**Peel Park Avenue
Clitheroe**

**Flood risk assessment
for proposed housing**

3/2018/0008- proposed housing at 30 Peel Park Avenue, Clitheroe- flood risk and drainage.

APPLICATION CONSULTATION RESPONSE

Flood 1:- 30 year

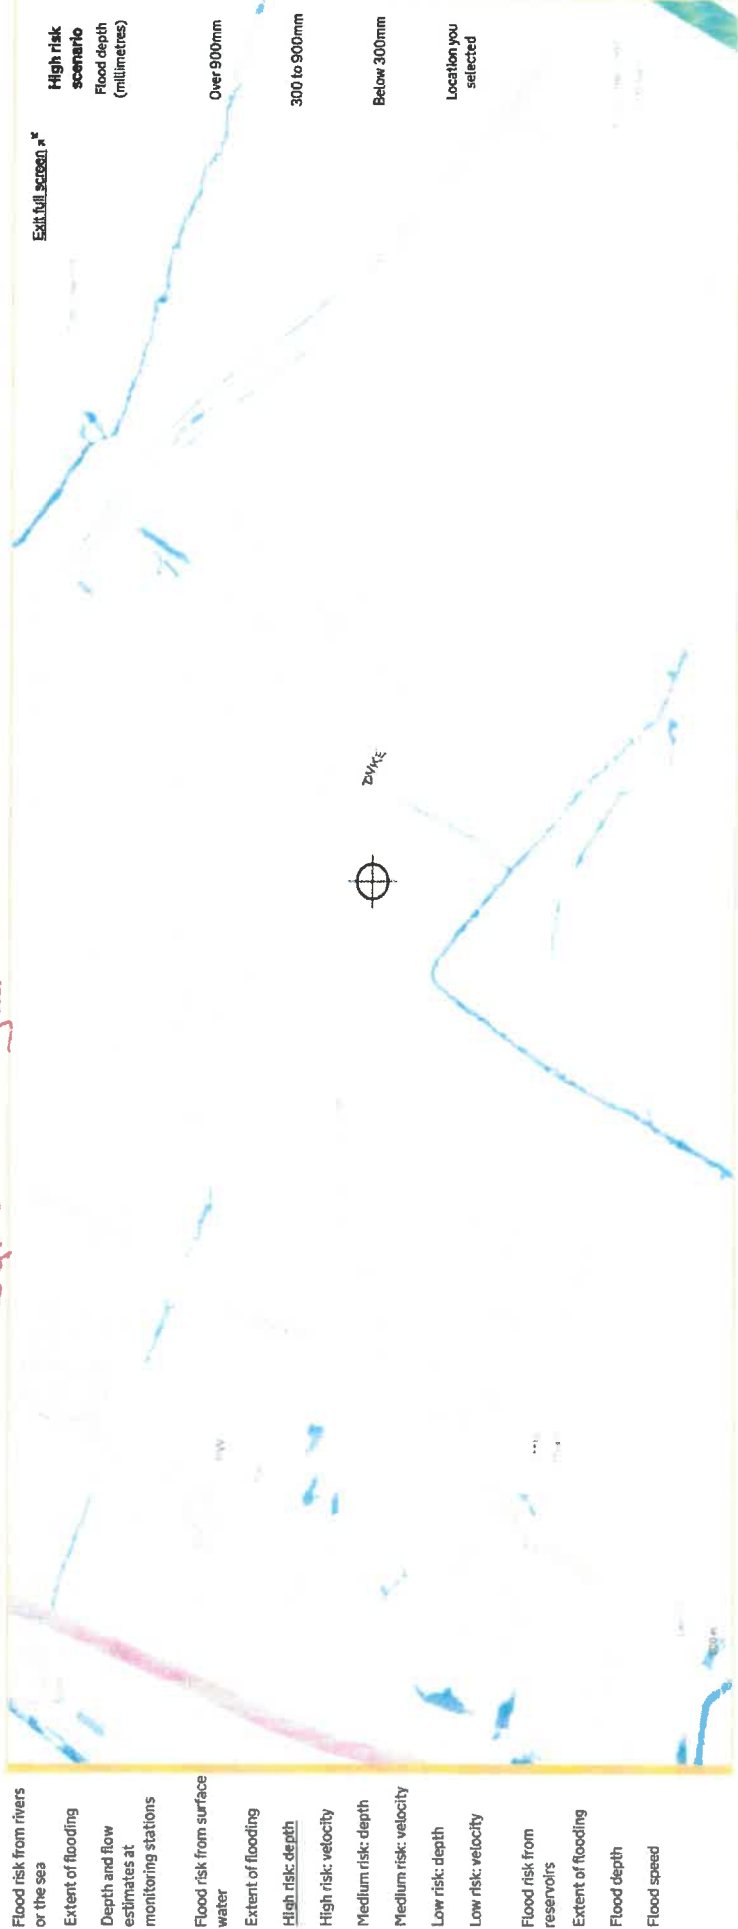
- a) Adequately assess the risk of surface water flooding to the site; specifically in regards to the surface water flood risk along the eastern and western boundaries of the site and the surface water flood risk around the proposed site access (including impacts on access/egress). The FRA also fails to provide sufficient details relating to mitigation measures that may be required in order to manage the risk of surface water flooding post development.

Whilst it is claimed in section 7 of FRA version 02 dated 07/12/17 that the existing ditch along the eastern boundary will mitigate the risk of overland flooding from higher land, it is noted that no evidence has been provided to substantiate this claim.

We provided Jflow/LIDAR mapping with our FRA on pages 12, 13, 14 of 171207attach2-A4 attachment and whilst this has limitations as per DEFRA guidance it does give a general assessment. For the avoidance of doubt we attach the same mapping at A3 size. A site walkover showed:-

2. Eastern boundary- there is a specific natural channel here lower than the site as is the adjacent eastern field area and this flows into the southern stream which is itself lower than the site-see photos also the Jflow approx mapping.

3. The proposed site access shows no Jflow surface water risk at 1 in 30 year and as Jflow mapping does not accurately take account of existing drainage, the 1 in 100 year and 1 in 1000 year maps merely show that the roadway will shallow flood in severe storms. Please note that Peel Park Avenue slopes westwards at 1 in 20 average and even intense storms will not give much flow depth in the road gutters.
